GFA AIRWORTHINESS DIRECTIVE

- TYPE AFFECTED:** ASH 26 E up to Serial Number 26134.
- SUBJECT:** Inspection and possible replacement of the rotor cooling fan.
- BACKGROUND:** Service experience has shown that cracking of the cooling impeller is possible.

GFA AD 491	ISSUE: 1	7 October, 1998	Page 2 of 5
-------------------	-----------------	------------------------	--------------------

ASH 26 EPrüfung des Lüfterrads der Luftinnenkühlung
*Checking the fan of the rotor cooling air system***Alexander Schleicher**

Fig. 1

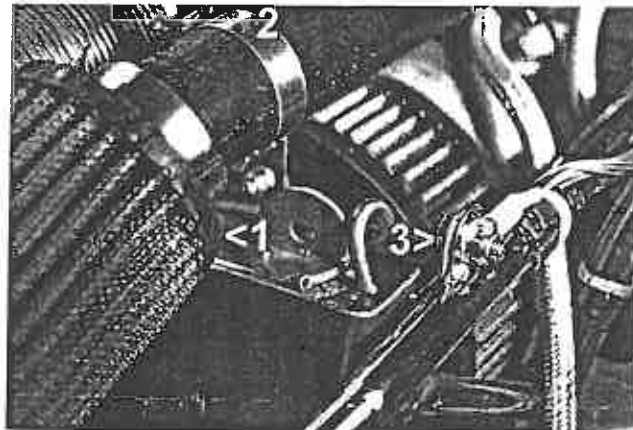
Gegenstand: Kontrolle des Lüfterrades der Innenluftkühlung auf Beschädigungen**Subject:** *Inspection of the rotor cooling air fan for damage.***Betroffen:** ASH 26 E entsprechend den Angaben in TM 5**Serial number applicability:** *ASH 26 E corresponding to TN 5***Maßnahmen:**
1. Hintere Befestigungsschraube (1) des Triebwerkes lösen. Diese Schraube führt durch den Öltank und kann nicht herausgezogen werden.
2. Schele (2) des Ansaugrohres lösen.
3. Öltank an der seitlichen Verschraubung (3) rechts lösen.**Action:**
1. *Undo the rear mounting bolt (1) of the engine system. This bolt is running through the oil reservoir and can not be removed.*
2. *Undo the clamp around the ram pipe.*
3. *Undo oil tank reservoir at the screw(3) on the right side.*

Fig. 2

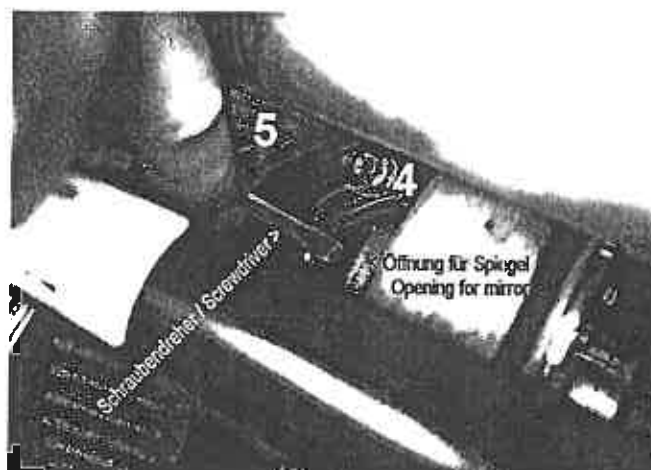
4. Schelle (4) des Kühlluftfilters (5) lösen.
5. Öltank vorsichtig nach hinten schieben.
6. Kühlluftfilter (5) ebenfalls so weit wie möglich nach hinten schieben und mit einem Schraubendreher den Gummifansch am Filter wegdrücken, damit mit einem Spiegel, wie in Fig. 3 dargestellt, das Lüfterrad im Inneren des Lüftergehäuses kontrolliert werden kann.
4. *Undo the clamp (4) at the rotor cooling air filter.*
5. *Move oil reservoir carefully to the back.*
6. *Move rotor cooling air filter (5) backwards, as far as possible and press the rubber flange of the filter to the back by means of a screwdriver, as shown in fig. 3, so that the fan inside the cooling air fan assembly can be inspected.*

Fig. 4

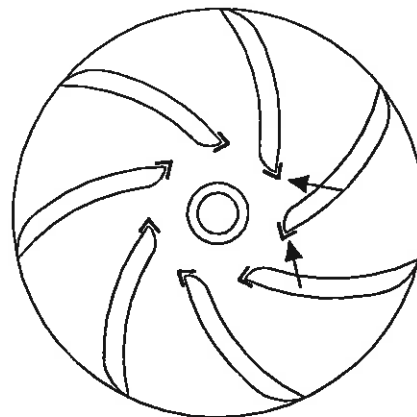
7. Lüfterrad an den in Fig. 4 gekennzeichneten Stellen kontrollieren, ob an den Lüfterradflügeln Risse vorhanden sind. Kurze, weiße Verfärbungen in diesen Kanten sind noch tolerierbar.
7. Check fan blades at the position marked in fig. 4 for cracks. Short, white discoloration at these edges is tolerable.
